City of Portland, Oregon
Bureau of Development Services
Land Use Services
FROM CONCEPT TO CONSTRUCTION

REVISED STAFF REPORT AND RECOMMENDATION TO THE DESIGN COMMISSION - APPROVAL

CASE FILE: LU 17-109861 DZ
(PC # 16-281887, DAR 15-265477)
1732 NE 2nd Ave
REVIEW BY: Design Commission
WHEN: October 5, 2017, 1:30pm
WHERE: ***Special Location***
CH2M Building, Lincoln Room
2020 SW Fourth Ave, Portland, OR 97201

NORTH ELEVATION

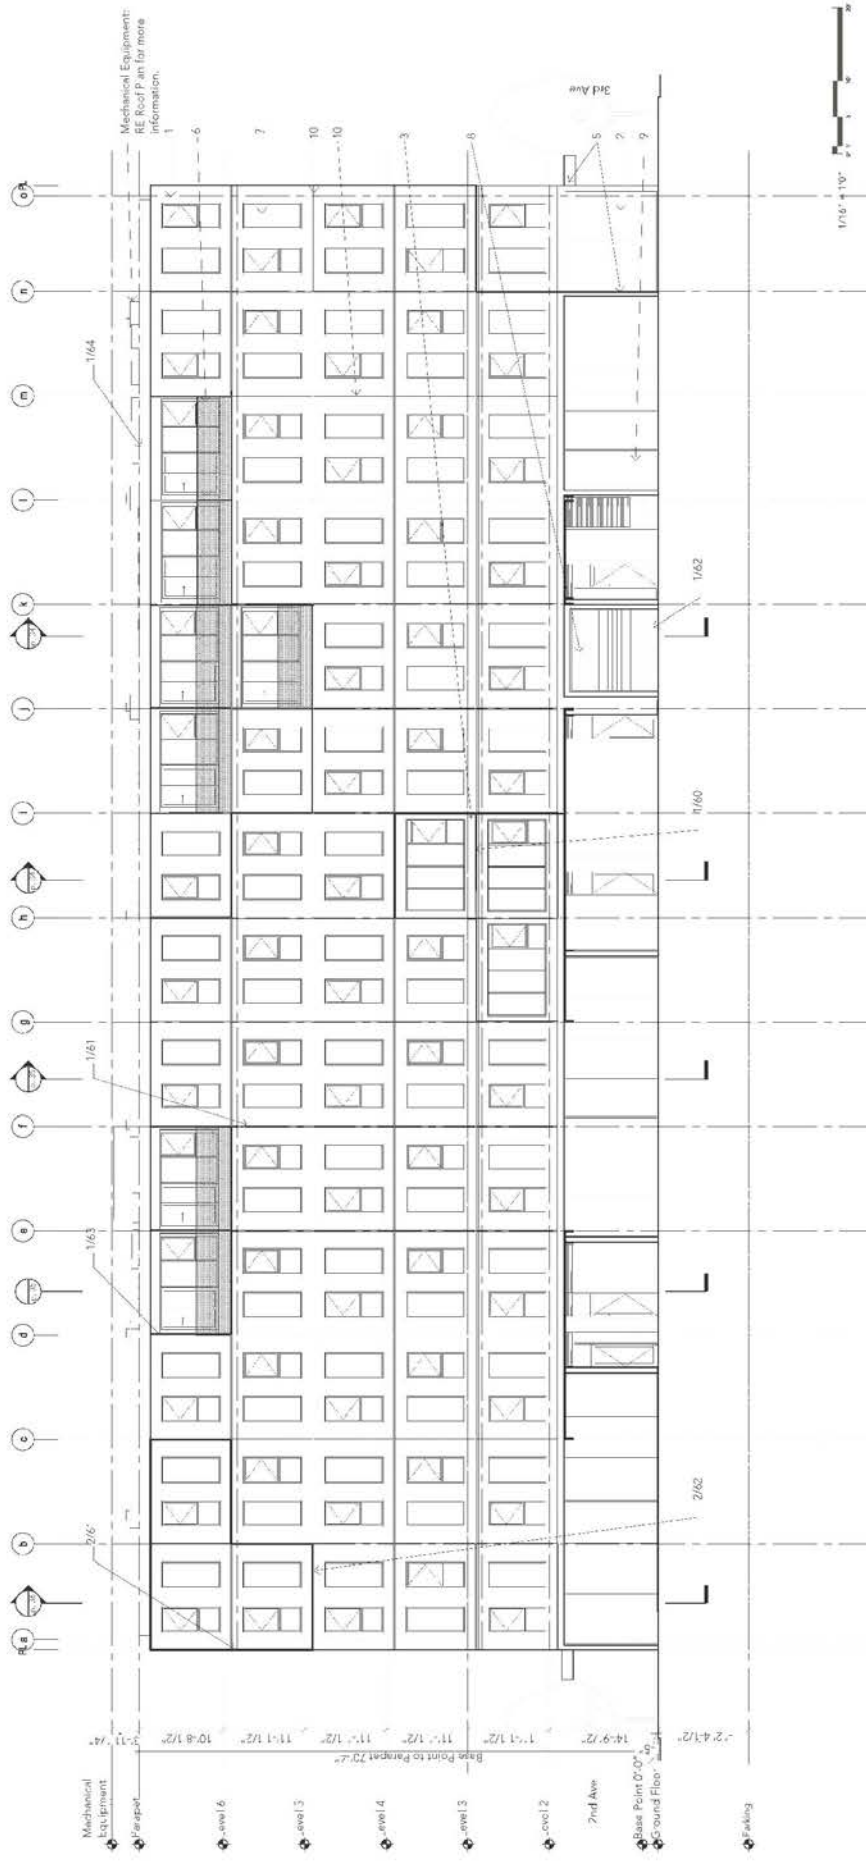
Since the first Design Review hearing, a Design Exception has been requested for the singular oriel window proposed on the 6th floor on the north elevation. Refer to the findings below under Design Exception for further detail.

This proposal seeks a modification to the oriel window 12 feet maximum length and the requirement for windows at all sides of projections greater than 2’-6” as outlined in ENB-15.51 and “*Window Projections Into the Right of Way*” Code Guide (6/1/2005). The building has been designed for modular construction. To showcase the capabilities of modular construction and to break up the facade, the building’s massing pushes and pulls the modular units to create a variety of cantilevers that provide visual interest on the façade. In one instance of this condition, the cantilever extends beyond the north boundary of the
